ITEM FOR ENVIRONMENTAL COMMISSION AGENDA

NAME & NUMBER OF PROJECT: Applied Materials Logistics Service Center
SP-2020-0321C

REQUEST: Variance request is as follows:
Request to vary from LDC 25-8-341 to allow cut to 12 feet.

STAFF RECOMMENDATION: Staff recommends this variance, having determined the findings of fact to have been met.

GRADING EXHIBIT

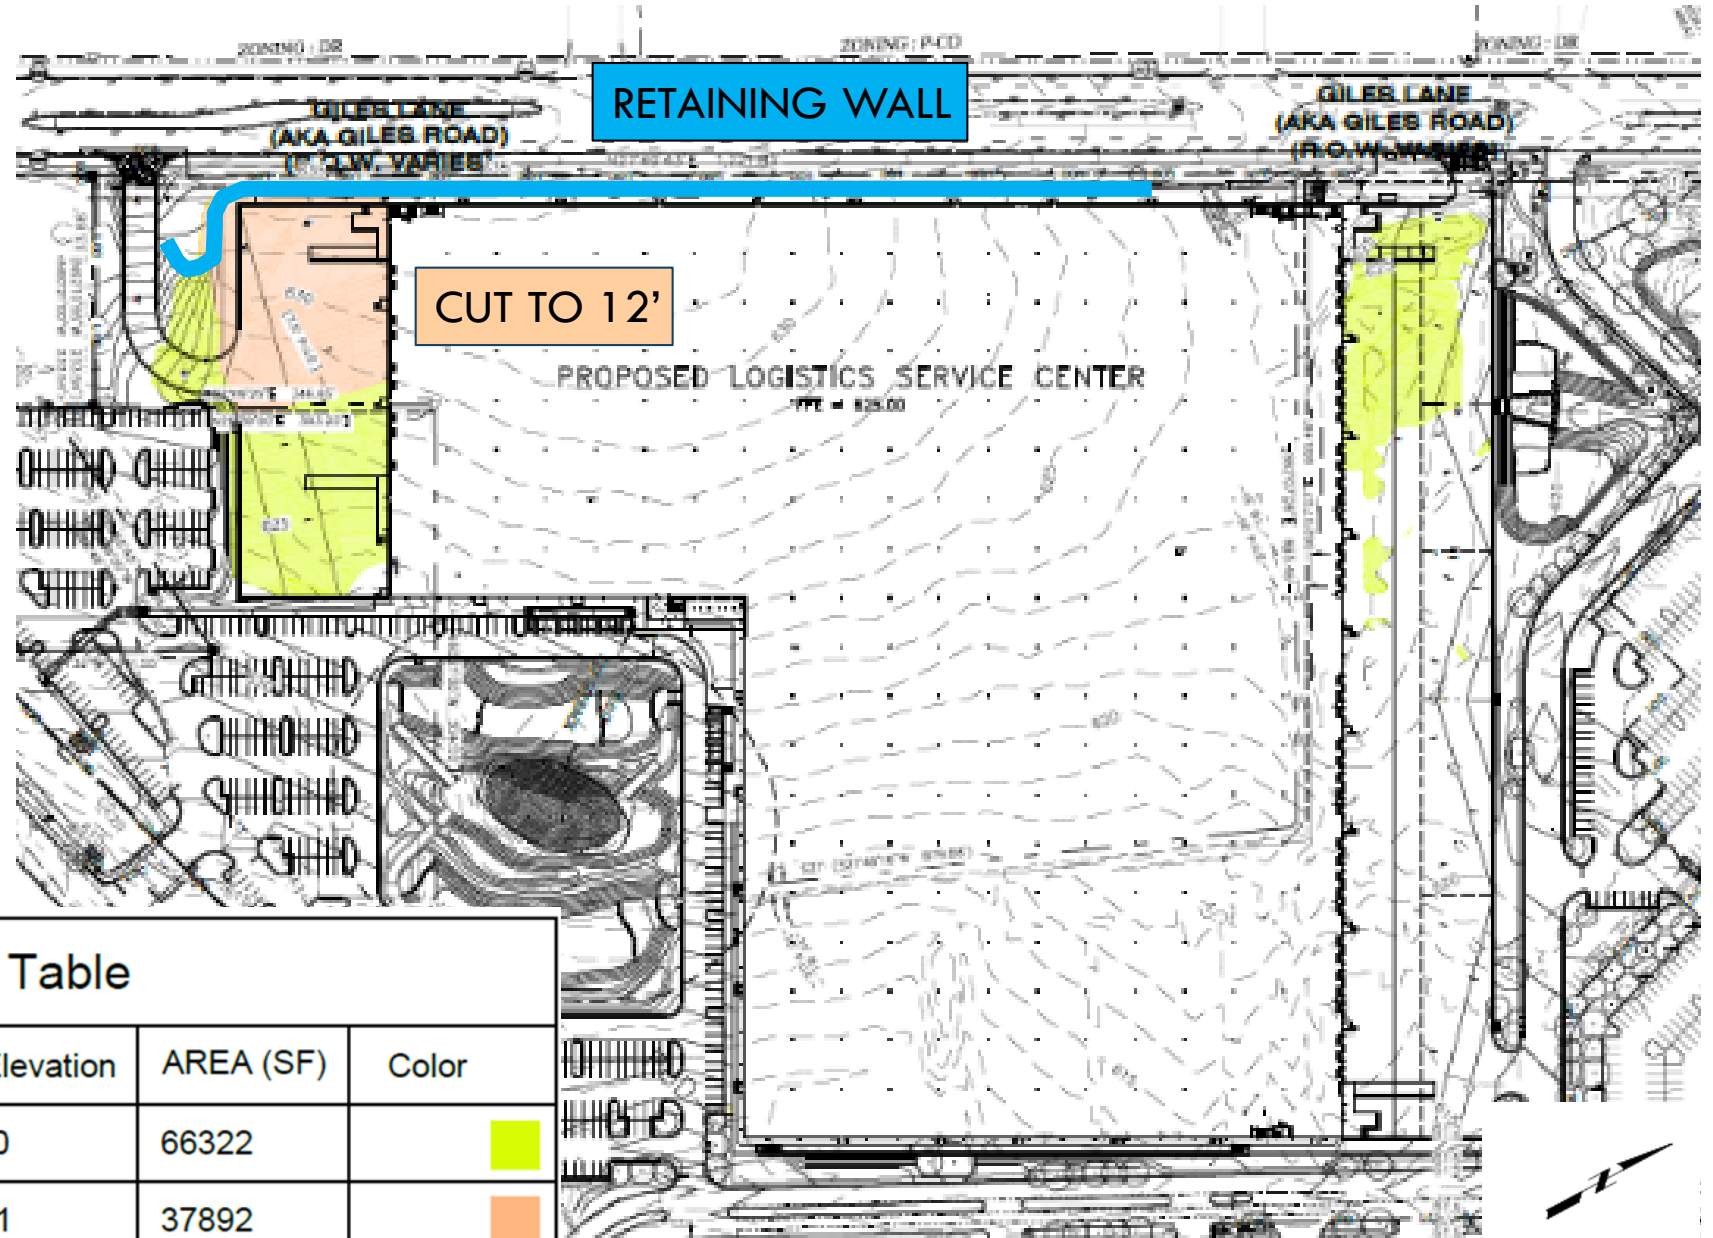
Yes The applicant intends to combine multiple warehouses into one consolidated warehouse at this location. Automated robotic equipment and human operated wheeled equipment to be used in the facility require a consistent floor elevation. The applicant proposes 699,000 square feet of warehouse space with a consistent floor elevation, as well as loading docks, fire lanes, and parking that will be constructed at elevations appropriate for the warehouse finished floor elevation. A consistent floor elevation is necessary for this type of automated warehouse. The applicant proposes to construct this facility on a site with minimal slopes (2% to 5%). However, the size of the warehouse necessitates cut up to 12 feet to achieve a consistent finished floor elevation. The applicant proposes cut up to 12 feet, which has been minimized by use of a retaining wall, as shown in Exhibit 1.

Cut to 12 feet is necessary in the south truck bay to maintain a standard 4-foot dock height.

Yes A retaining wall on the west side, parallel to Giles Lane, minimizes the extent of cut adjacent to the building. The truck court grades slope with the natural contours as much as possible while maintaining minimal slopes to facilitate the maneuverability and circulation of the truck traffic. The applicant has selected a relatively flat site for the proposed warehouse, helping to minimize the required grading.

STAFF CONDITION: Applicant will stockpile and preserve topsoil for reuse in landscape, wetland mitigation, and/or biofiltration areas.
